#### **Addendum 128 – UN Regulation No. 129**

#### **Revision 4 - Amendment 4**

Supplement 4 to the 03 series of amendments – Date of entry into force: 3 January 2021

#### **Uniform provisions concerning the approval of Enhanced Child Restraint Systems used on board of motor vehicles (ECRS)**

Figure 2

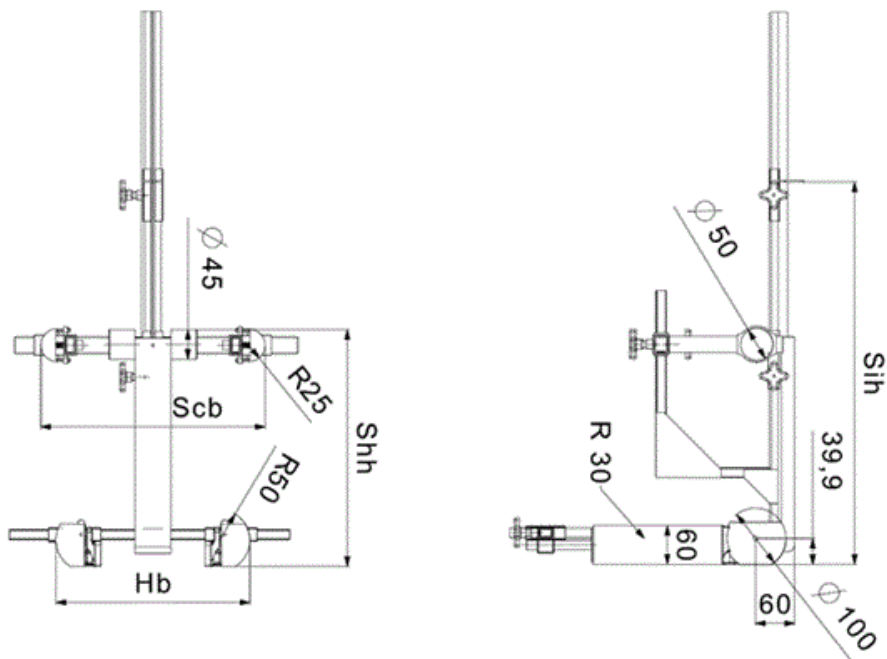
Annex 18., amend to read:

For integral or non-integral ECRS the device shown in Annex 18, Figure 2 shall be used.

The mass of the devices described in Figure 2 and Figure 3 shall be 10 kg +/- 1 kg.

All measurements shall be taken with the device base in contact with the seat pan of the ECRS and the device backrest in contact with the backrest of the ECRS. All lateral dimensions shall be measured under a contact force of 50 N with the devices described in Figure 2 and Figure 3 of this annex.

Figure 3

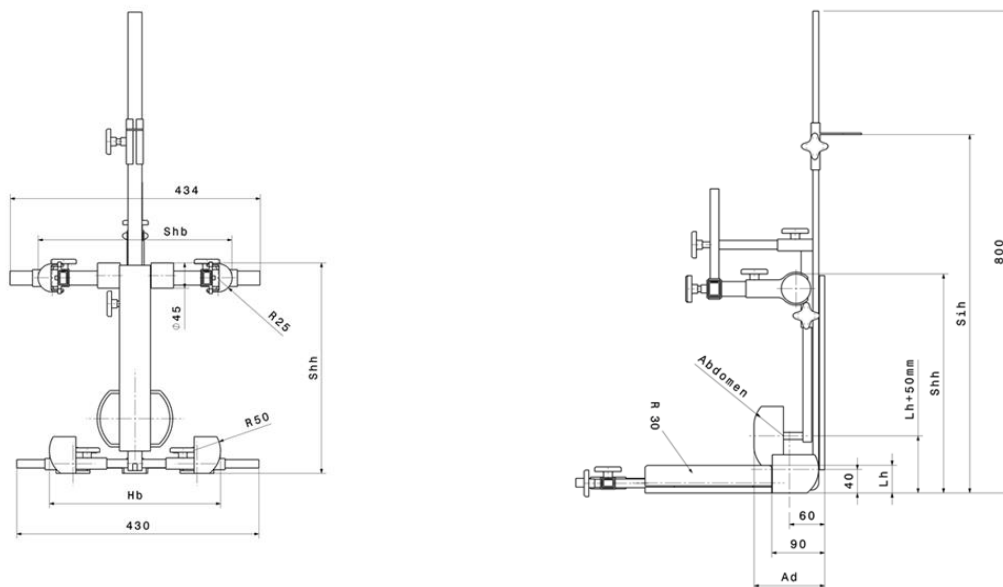
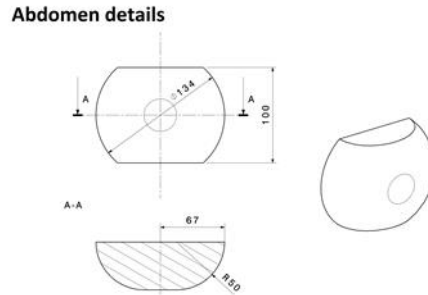
**Side and Front View of the measuring device for measurements applicable to Enhanced Child Restraint Systems that feature an impact shield**

For ECRS with an impact shield the device shown in Annex 18, Figure 3 shall be used.
